May 22, 2018

Mr. Frank DeFrancesco, Chief
Dams and Waterway Section
Pennsylvania Department of Environmental Protection
2 East Main Street
Norristown, PA 19401

**Re: SPLP Response to Comments
Hydrogeological Reevaluation Report
Arch Bishop/South Chester Road HDD (S3-0541)
DEP Permit Nos. E15-862 and E23-524
Westtown and Edgemont Townships
Chester and Delaware Counties, Pennsylvania**

CHESTER/DELAWARE COUNTY PENNSYLVANIA, WESTTOWN/EDGMONT TOWNSHIP
S3-0541-16

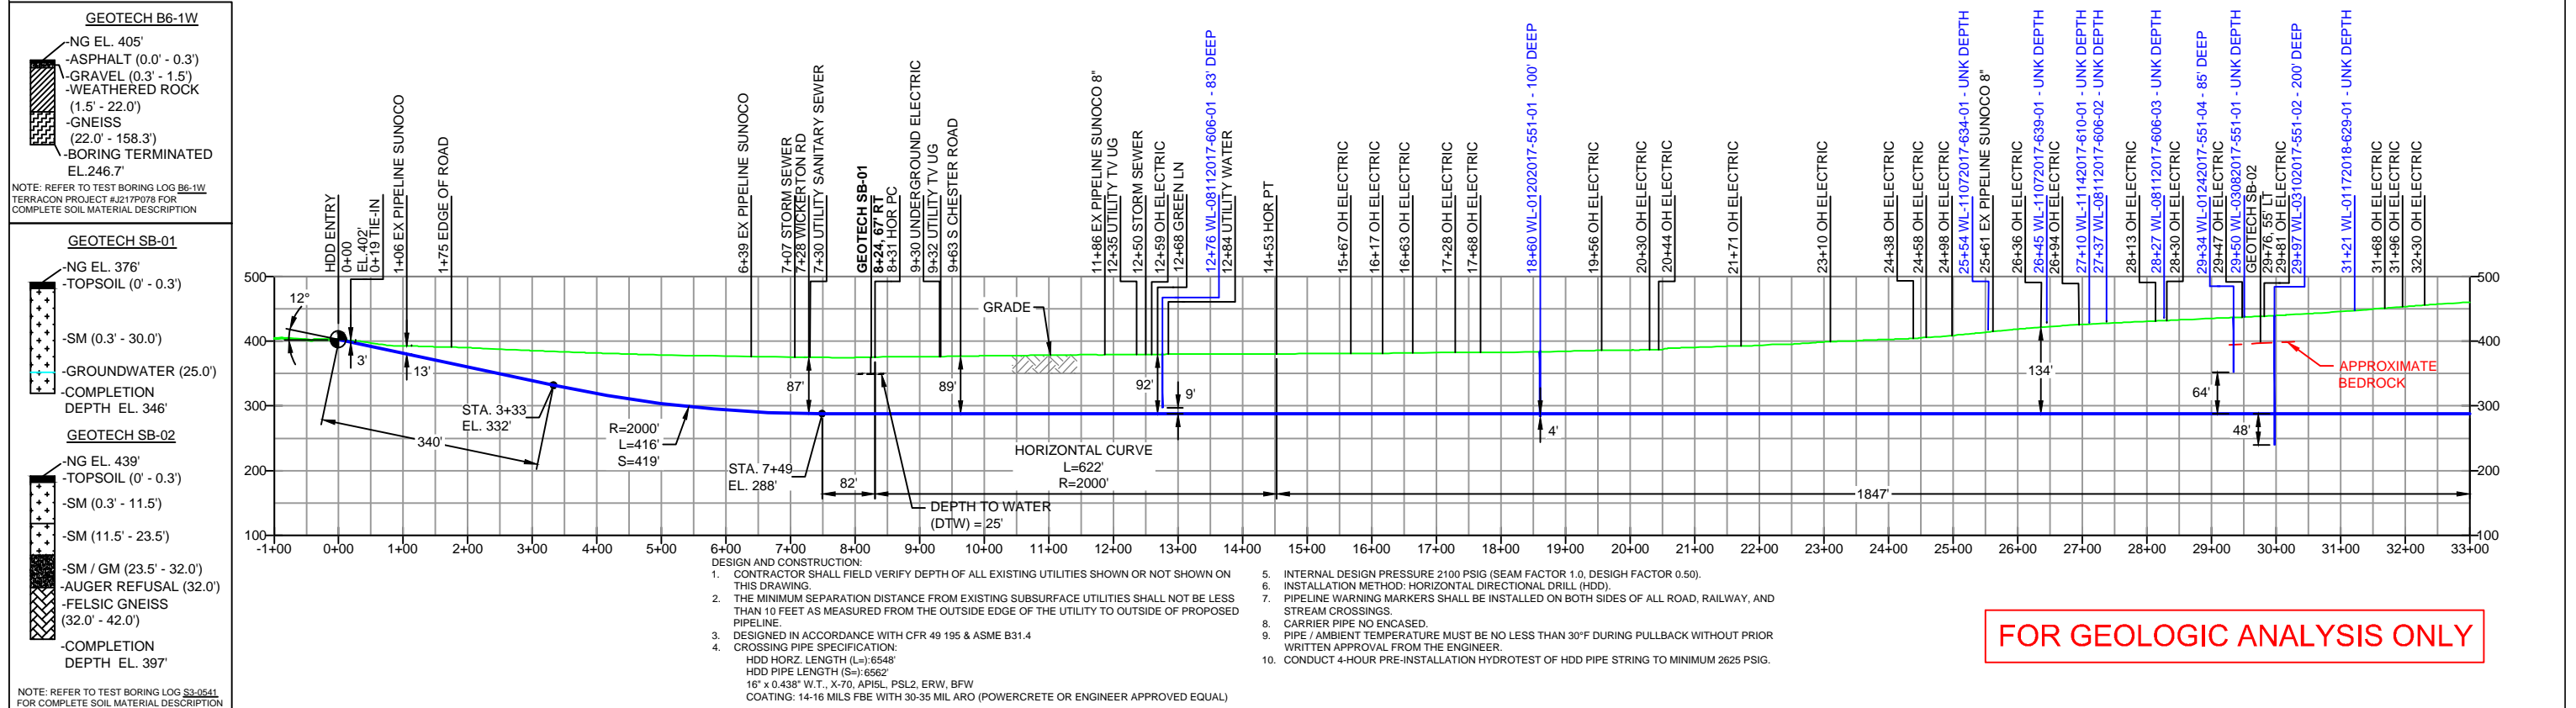
6. There are reported intersections of fracture traces with the planned HDD bore path within close proximity to residential supply wells. The HDD alignment crosses six fracture traces mapped as part of reevaluation, but these fracture traces are not discussed as they relate to well locations and proximity to bore path. Further discuss these fracture traces, map them on present day aerial photos, evaluate them for potential problem areas, and provide this information, including the results of the evaluation, to DEP.

- b. Project water wells depths, casing depths and water-level depths (based on a water-level survey) on cross sections/profile views.**

- c. Identify zones of fractures or fracture trace intercepts on the profile views, along with residential water supply well locations.**

b. The top of rock level appears to be 22 feet below ground surface at Boring B6-1W and there is likely shallow depth-of-cover over the HDD bore at the existing Sunoco pipeline crossing (Station 1+06) as well as at Wickerton Road (Station 1+75). The Report explicitly states that casing is being provided for the pilot hole at the SE entry, but does not state the same for the NW entry. This needs to be clarified.

A plot of the approximate fracture traces on the HDD profile (see **Attachment 4**) indicates that several residential wells in the 450-foot sampling program may lie on or near a potential fracture. The fracture trace locations were derived from stereographic imagery using aerial photographs from 1943, and then transposed on current aerial maps; thus, a small degree of error in plotting accuracy exists, and the fracture trace locations are described as “approximate.” Fracture traces are the surface representation of vertical to near vertical planar zones of fracture concentration, thus a well would have to be very close to a fracture trace to be intersected by it. The wells which are closest to fracture traces are from 54 to approximately 500 feet from the HDD borepath, occurring between Stations 35+00 to 45+00 as shown on the HDD profiles. The use of Aquabloc will mitigate the travel of groundwater through fractures, and of drilling fluids away from the bore path. SPLP will follow the Operations Plan and Water Supply Plan, by adhering to the notification, sampling, and monitoring procedures outlined therein, to ensure all affected residents will have potable drinking water. (Also see answer to 5(a).)

Attachment 4 presents a set of the HDD profiles with water well depths and water levels if known represented in the cross-section view.

The set of HDD profiles in Attachment 4 has the fracture trace intercepts included on the plan view.

As shown on the HDD profiles, the occurrence of a Sunoco pipeline at Station 1+06 is on the proposed 16-inch profile (Station 0+76 on the 20-inch profile). On both profiles, the area

around Station 1+75 is noting “edge of road”. Wickerton Road occurs at Station 7+48 on the 16-inch profile and Station 7+46 on the 20-inch profile.
